[Docket No. 12425; Amdt. No. 53-59]

PART 93—SPECIAL AIR TRAFFIC RULES AND AIRPORT TRAFFIC PATTERNS

Anchorage, Alaska, Airport Traffic Area

I. ANCHORAGE AIRPORT TRAFFIC AREA; TRAFFIC PATTERNS

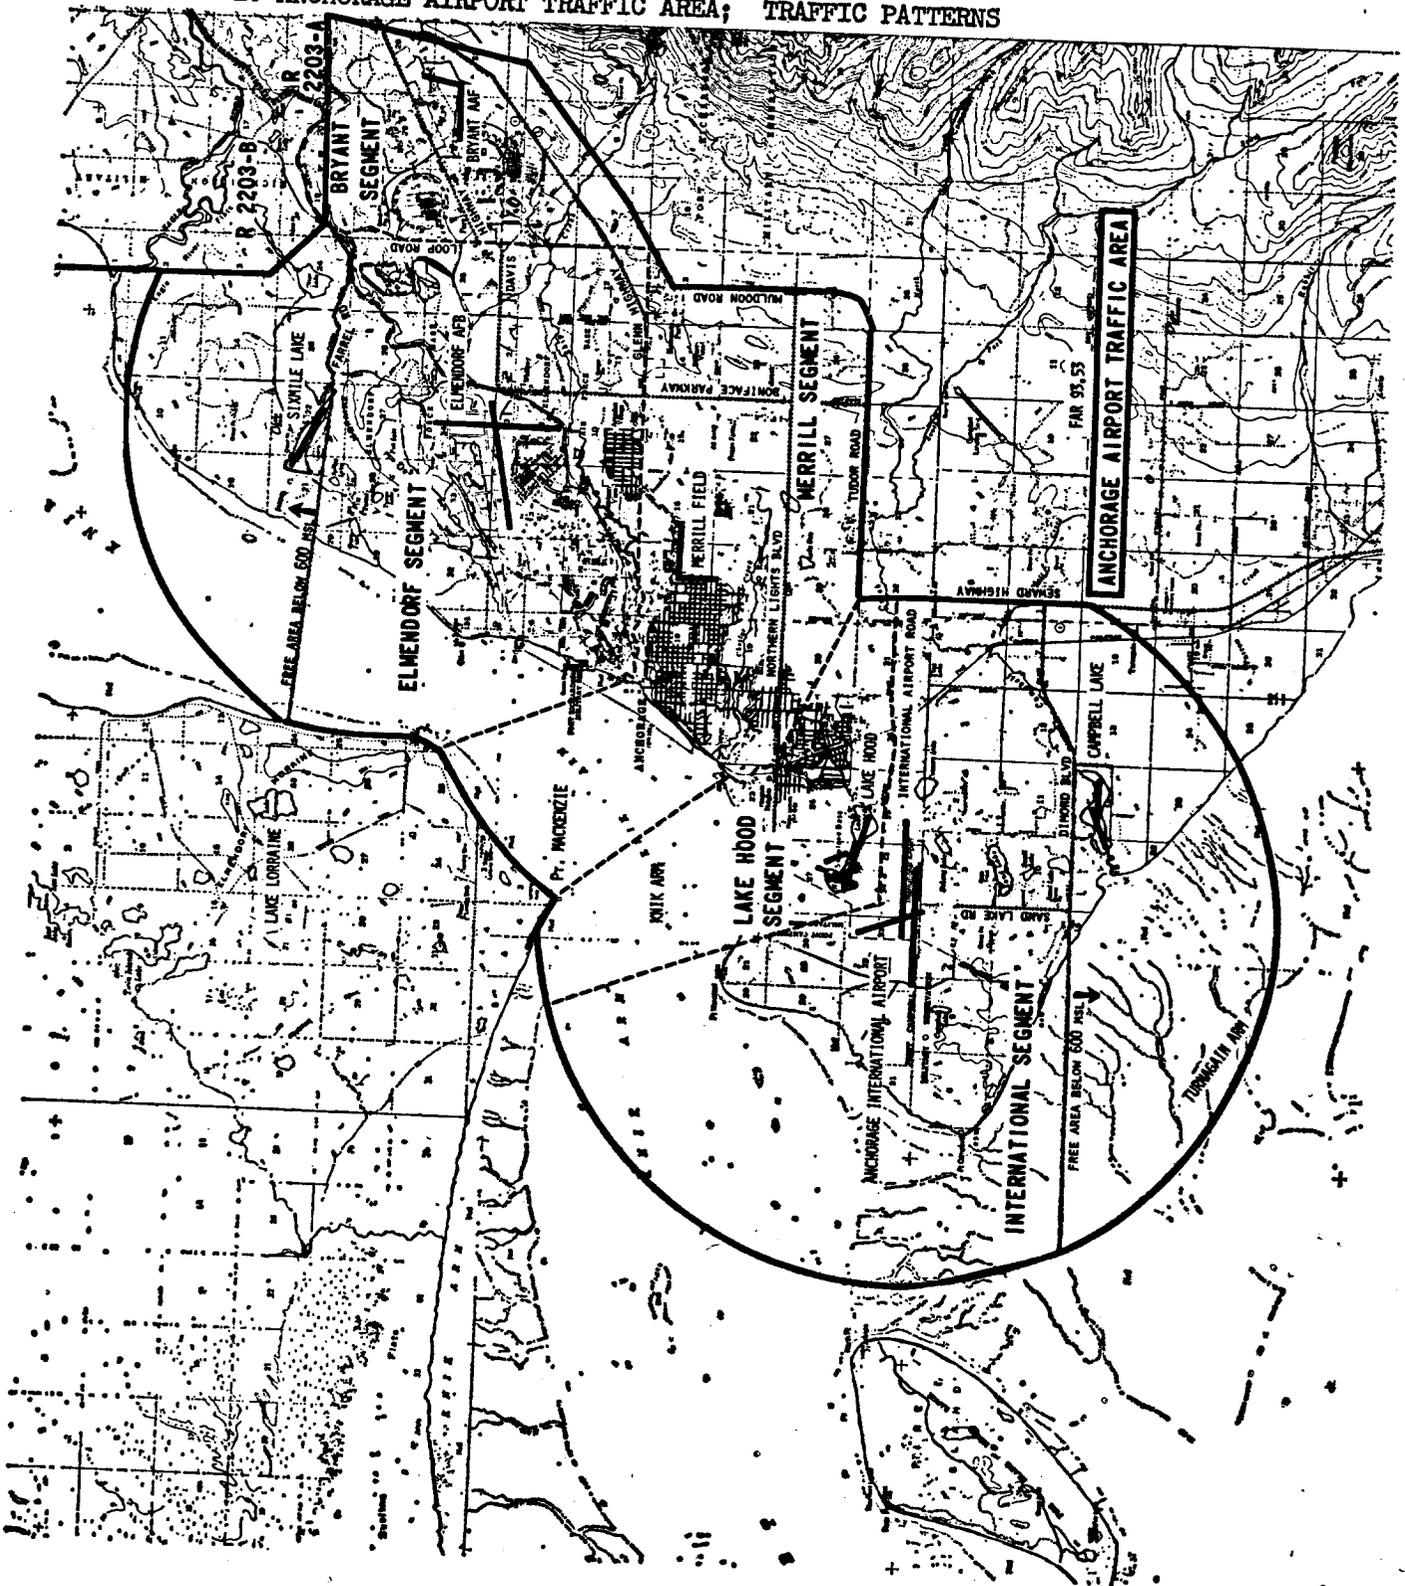
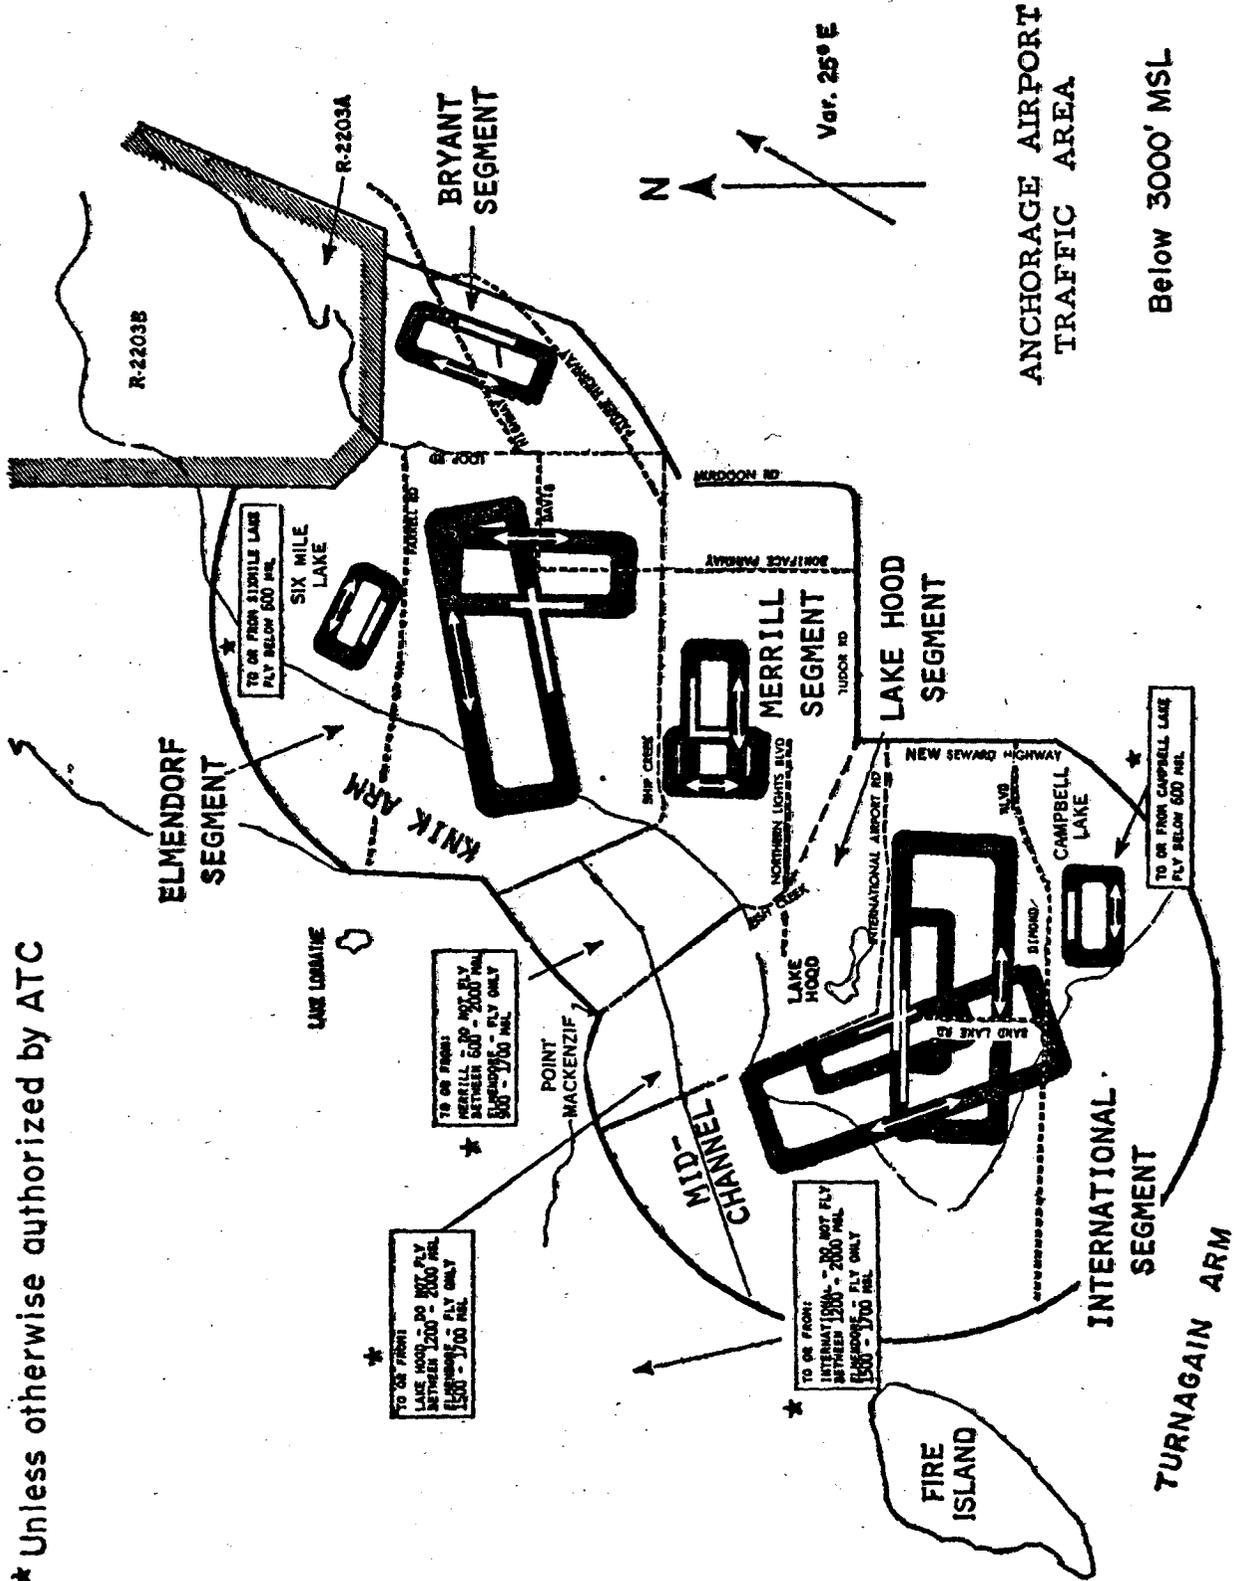
5. The first two diagrams (Anchorage Airport Traffic Area) in Appendix A are amended to reflect the changes effected by Items 1 and 2, above. The two diagrams, as amended, are set forth below.
